# Access Compliance Report

## Public Rights-of-Way

### (Curb Ramps)

Intersection ID: 12413	Main Street: N_BREVARD_ST	Cross Street: E_6TH_ST	Location: S
ADA ID: 3C9D6B8B728B	Ramp Type: PerpDiag	Initial Pass/Fail: Fail	Overall Compliance: No
		Severity Score: 35

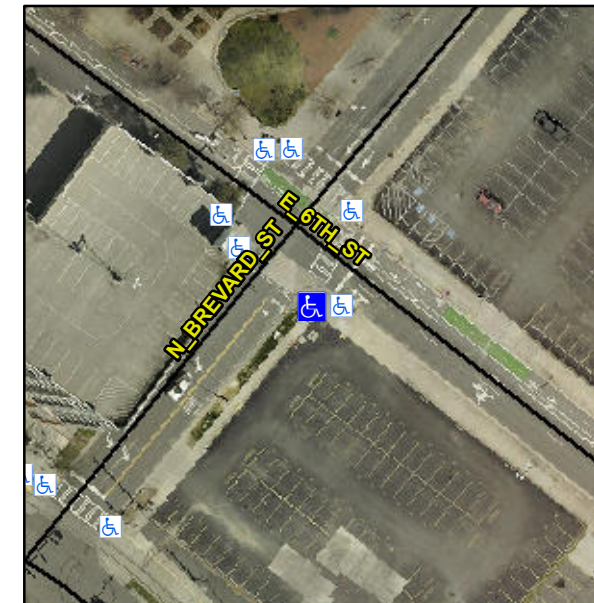
**Not Found, R304.5.1**

Compliance	Description	Data	Compliance	Description	Data
N/A	Ramp Length (in)	84.0	Yes	Ramp Slope (%)	8.0
No	Ramp Width (in)	24.0	Yes	Ramp XSlope (%)	0.3
N/A	Flare Type LT	N/A	N/A	Flare Type RT	N/A
N/A	Flare Slope LT (%)	N/A	N/A	Flare Slope RT (%)	N/A
N/A	Flare Traversable LT?	N/A	N/A	Flare Traversable RT?	N/A
N/A	Landing Length (in)	N/A	N/A	DWS Provided?	N/A
N/A	Landing Width (in)	N/A	N/A	DWS Contrast?	N/A
N/A	Landing Slope (%)	N/A	N/A	DWS Length (in)	N/A
N/A	Landing X Slope (%)	N/A	N/A	DWS Full Width?	N/A
N/A	Landing Curb? (Y/N)	N/A	N/A	DWS Offset (in)	N/A
N/A	Shared Landing?	N/A			
N/A	Gutter Ponding?	N/A	N/A	Gutter Slope (%)	N/A
N/A	Gutter Lip Ht (in)	N/A	N/A	Gutter X Slope (%)	N/A
N/A	Painted X Walk1?	Yes	N/A	Painted X Walk2?	Yes
	X Walk 1 Direction	To NE		X Walk 2 Direction	To NW
N/A	X Walk 1 Width (in)	112.0	N/A	X Walk 2 Width (in)	112.0
	X Walk 1 Slope (%)	1.8		X Walk 2 Slope (%)	1.0
	X Walk 1 X Slope (%)	0.9		X Walk 2 X Slope (%)	0.6

**Remove & Replace Curb Ramp With Two New Directional Ramps or Equivalent.**
